INCH-POUND
MIL-L-0044259B (GL)
AMENDMENT 1
5 April 1990

MILITARY SPECIFICATION

LIGHT SET, PORTABLE, FLUORESCENT

This amendment forms a part of MIL-L-0044259B (GL), dated 2 January 1990, and is approved for use by the Natick Research, Development and Engineering Center, Department of the Army, and is available for use by all Departments and Agencies of the Department of Defense.

FIGURE 1. 1976 UNIFORM CHROMATICITY SCALE DIAGRAM SHOWING ALLOWABLE COLOR CIRCLE FOR FILTER.

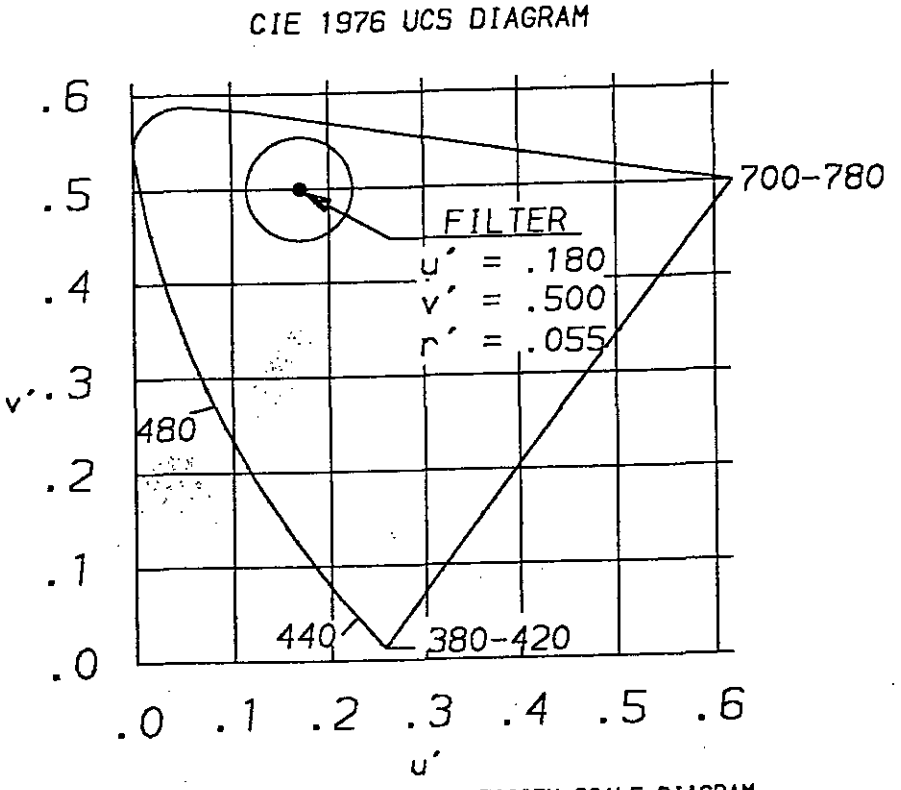
3.4.10.1, line 2: Delete "12 - 16%" and substitute "15 - 20%"; at the end: Add "The filter shall meet the chromaticity requirements of u'=.180, v'=.500, and r'=.055 on Figure 1. No more than .5 percent of the total energy emitted shall be above 700 nanometers and begin as close to 600 nanometers as possible. Ninety-five percent of the total energy should be confined within 400-600 nanometers."

Add: Figure 1
